BID: CPST-07
COTTAGEVILLE RECREATION AREA PROJECT
72 SALLEY ACKERMAN DRIVE

Addendum #2
dated 6-7-2017

Answers to questions and revised plans

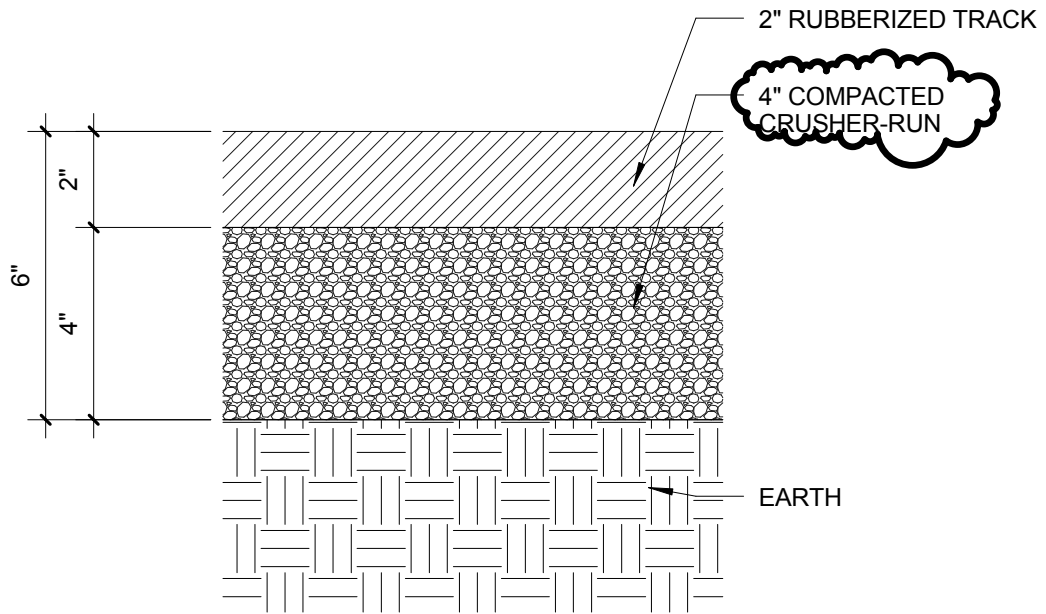
Grill will need to be embedded in the new slab shown on Detail 1/A102 in lower right-hand corner denoted by call out 6/A101 close to column line 6 and column line C.
